PEIR Chapter 13 Notes – Road Drainage and the Water Environment

Identified Issue(s):

Figure 1: Grey Route Drainage to LID_AQ101

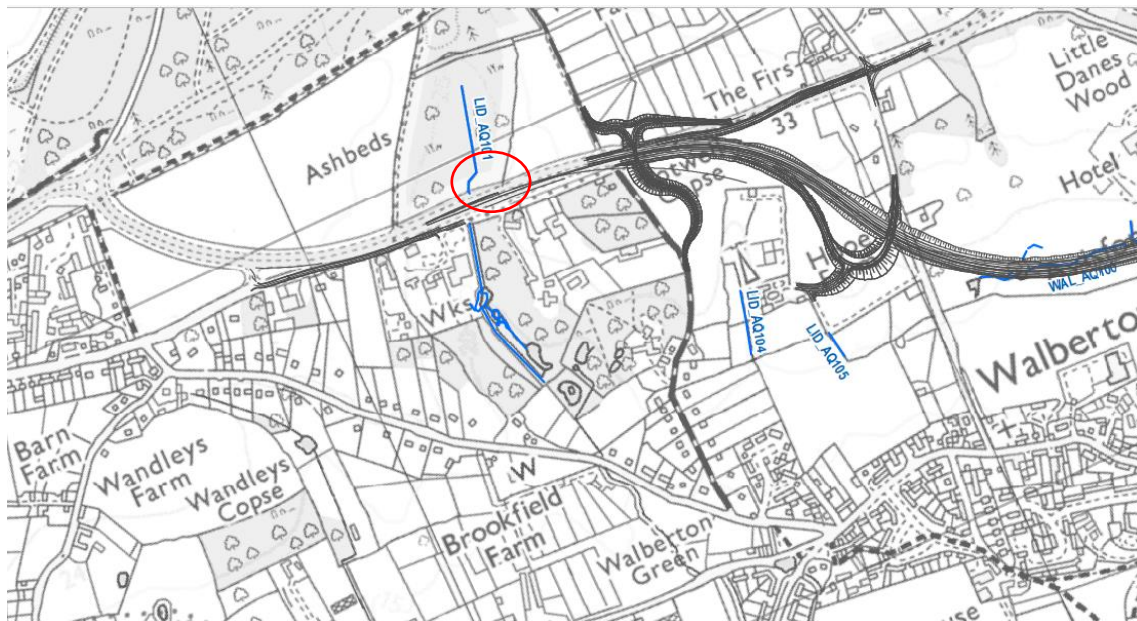
Therefore, potential challenge arises from the statement given in **Paragraph 13.5.32** – ‘**...A discharge of attenuated drainage from the Scheme to the tributary (LID-AQ101) would be required**’. The drainage channel identified as taking future operational road drainage is the existing watercourse identified as LID_AQ101 that rises in ‘Ashbeds’ north of the existing A27 and runs south adjacent to Fordingbridge Engineering (Figure 1)

This watercourse is described in 13.5.16 as a tributary of Lidsey Rife. However, the route of the stream to Lidsey Rife is a convoluted pathway that runs south from the proposed point of discharge, through Hazel Plantation before crossing beneath West Walberton Lane. This channel then flows south to Eastergate Lane before splitting into separate channels. One of the channels feeds Walberton Pond. A viable connectivity pathway is therefore present between the proposed discharge point and Walberton Pond.

Figure 3: Location of Proposed Drainage Discharge to LID_AQ101 without Indication of Attenuation Pond Provision

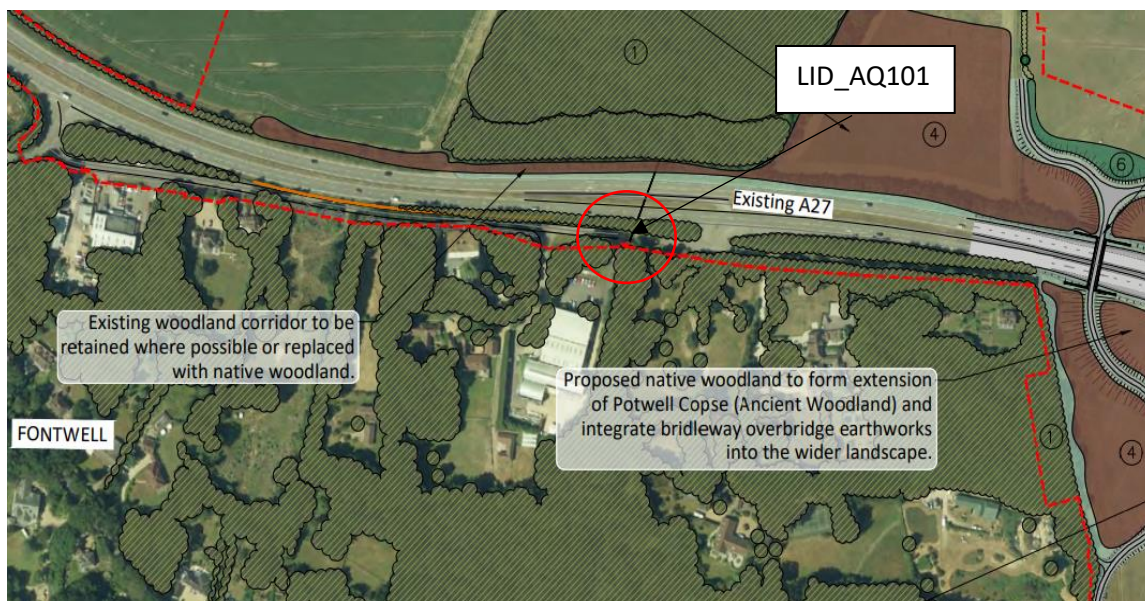
Although the statement given in Paragraph 13.5.32 states that the discharge to LID_AQ101 will be attenuated, there is no attenuation pond illustrated in the PLEM at the discharge location (Figure 3). It should however be noted that wording in the PLEM Table 13-A-8, Page 362, states that ‘*Treatment and attenuation to be provided by ponds, swales and oversized pipes*’. However, details are not provided and attenuation does not fully address pollution risk. It is therefore not clear at this stage that the ponds at Hazel Plantation and Walberton will be safeguarded as it does not appear that they have been adequately assessed in this regard.

It is not clear that the proposed attenuation ponds identified in Paragraph 13.8.7 and illustrated in PEIR_Volume_3_Figure_2_1 (Preliminary Landscape and Environmental Masterplan (PLEM)) will have a role in preventing downstream impacts from road drainage discharges to LID_AQ101 and connected streams/ponds. Given the geomorphology of the western extent of the scheme, it does not appear feasible that discharges to LID_AQ101 can be attenuated by the proposed ponds set out in the PLEM. This is due to land gradients and flow direction being to the southwest and therefore away from the proposed attenuation ponds. Attenuation via the currently proposed ponds would require a system

of pumping stations and associated pipework to achieve. To date, pumping stations and pipework have not been presented as a scheme requirement.
